REGIONAL REVIEW FINDING

ARC REVIEW CODE: R803201

Submitting Local Government: City of Woodstock
Name of Proposal: The Avenue Ridgewalk

Preliminary Report:	March 20, 2008	DEVELOPMENT OF REGIONAL IMPACT REVIEW REPORT	Project:	The Avenue Ridgewalk #1594
Final Report Due:	April 19, 2008		Comments Due By:	April 3, 2008

V/C Ratios

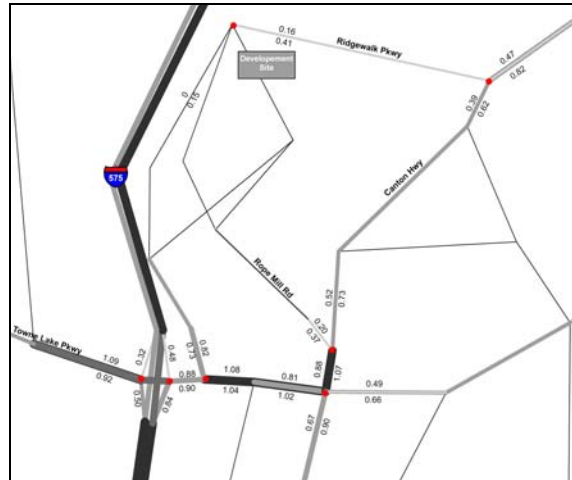
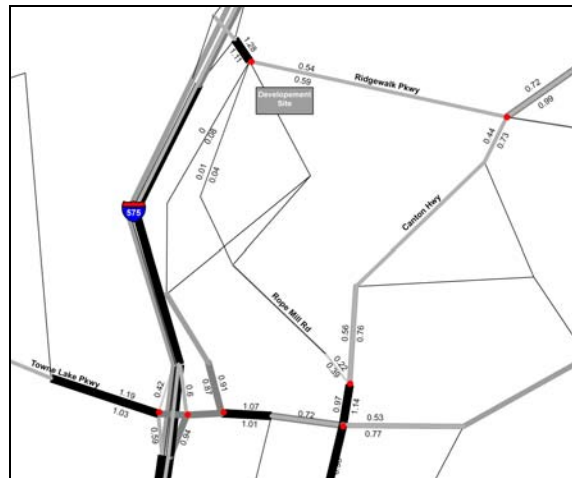
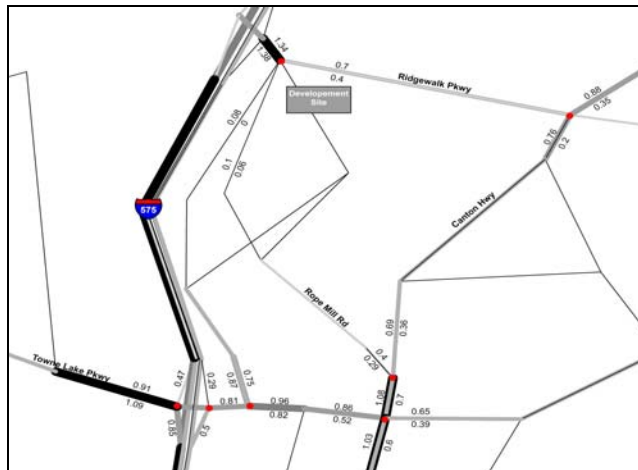
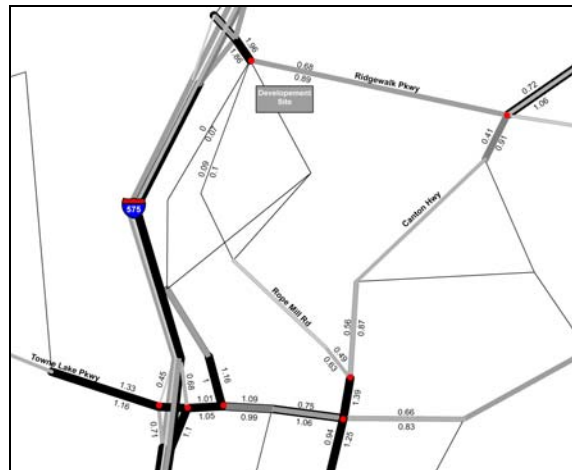
For the V/C ratio graphic, the data is based on 2010, 2020 and 2030 AM/PM peak volume data generated from ARC's 20-county travel demand model utilizing projects from Envision6 and the FY 2008-2013 TIP. The 20-county networks are being used since they consist of the most up to date transportation networks and data. The travel demand model incorporates lane addition improvements and updates to the network as appropriate. As the life of the RTP progresses, volume and/or V/C ratio data may appear inconsistent due to (1) effect of implementation of nearby new or expanded facilities or (2) impact of socio-economic data on facility types.
